| • **CLIMATE CONTROL—CLICKING NOISE FROM TEMPERATURE BLEND DOOR ACTUATOR—VEHICLES PRODUCED 11/13/2000 THROUGH 4/1/2001**<br>• **NOISE—CLICKING NOISE FROM CLIMATE CONTROL TEMPERATURE BLEND DOOR ACTUATOR—VEHICLES PRODUCED 11/13/2000 THROUGH 4/1/2001** | **Article No. 01-12-6** |

**FORD:** 2002 EXPLORER

**MERCURY:** 2002 MOUNTAINEER

Figure 1 - Article 01-12-6

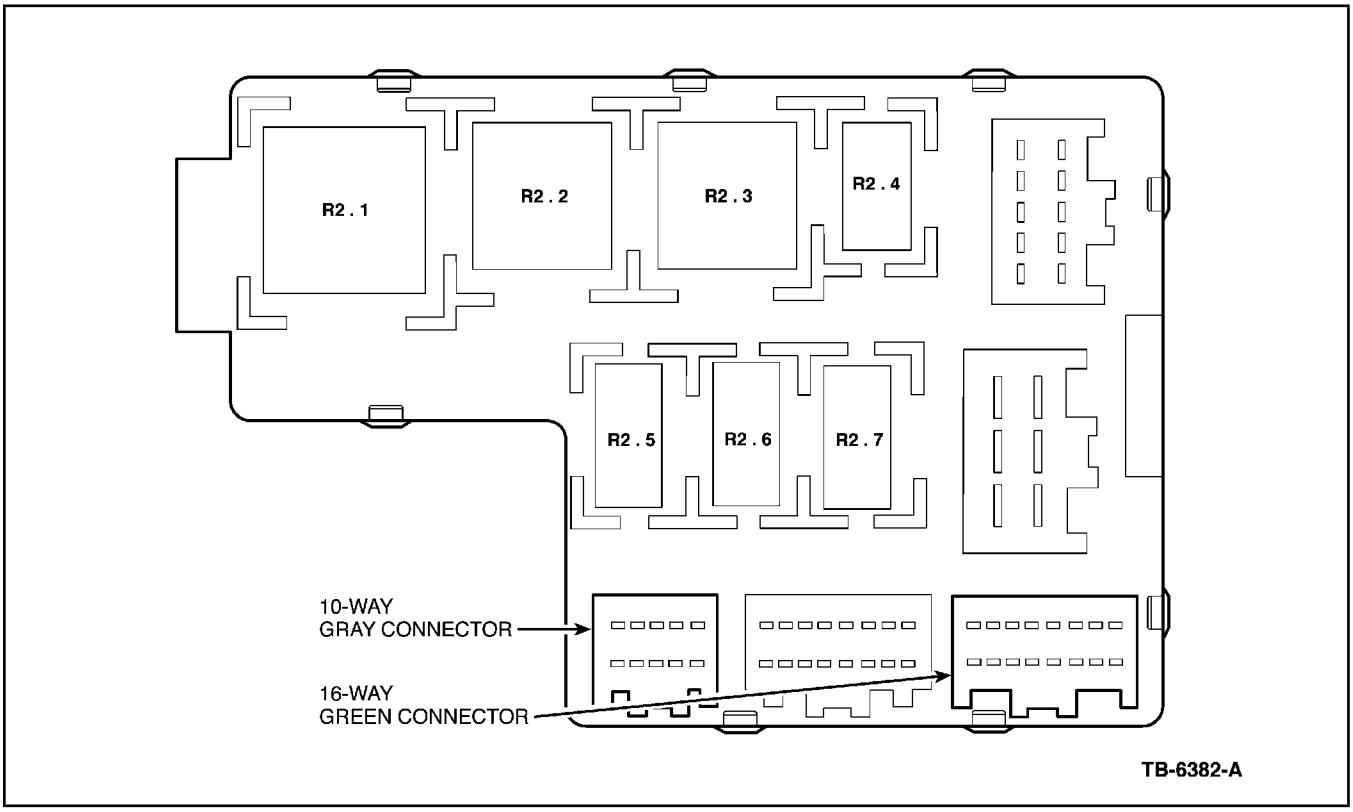
3. On the upper side of the junction box (relay locations), locate the 16-way green connector on the outboard side of the junction box (Figure 1).
4. Remove the green connector from the junction box.

7. On the gray/yellow wire, strip the wire insulation away and prepare for a splice. This wire will be used later in the procedure.
8. Reinstall the spacer on the engagement end of the green connector and install connector in the junction box (Figure 1).

9. Locate the 10-way gray connector on the inboard side of the junction box (Figure 1).
10. Remove the gray connector from the junction box.
11. Locate cavity #2, light green/purple wire (Figure 2).

15. Install the gray connector in to the junction box (Figure 1).
16. Reposition the junction box under the instrument panel and reinstall the 3 attaching screws. Torque to 2.4 ± 0.4 N•m (21 lb-in ± 3.5 lb-in.)

Figure 2 - Article 01-12-6

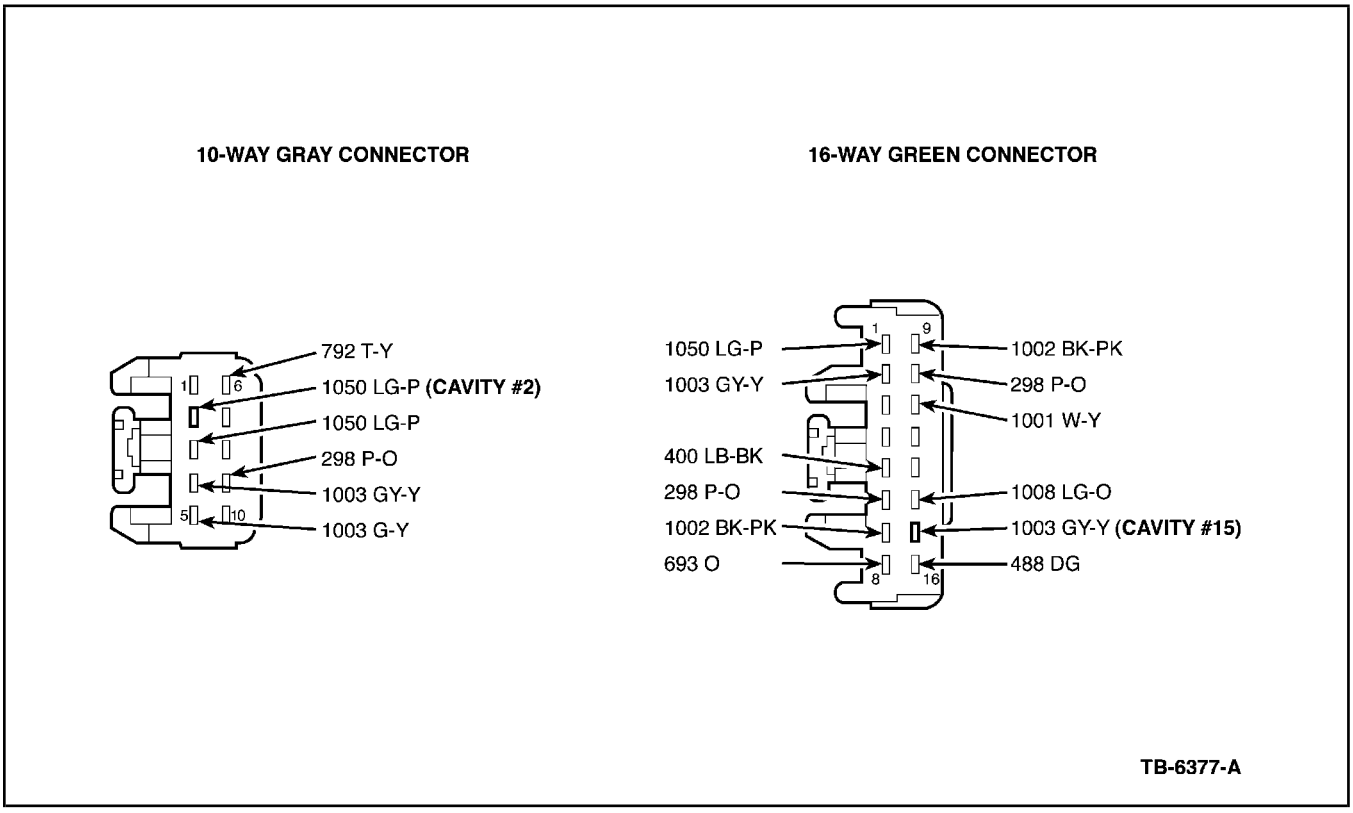
5. Remove spacer from the engagement side of the connector.
6. Locate cavity 15 (gray/yellow wire), remove terminal from connector, and cut off terminal (Figure 2).

12. Center splice into this wire by spreading the insulation apart.
13. Locate the gray/yellow wire from Step 7.
14. Attach the gray/yellow wire to the light green/purple wire. Crimp a wire splice onto the two wires, solder the splice and cover with electrical tape.
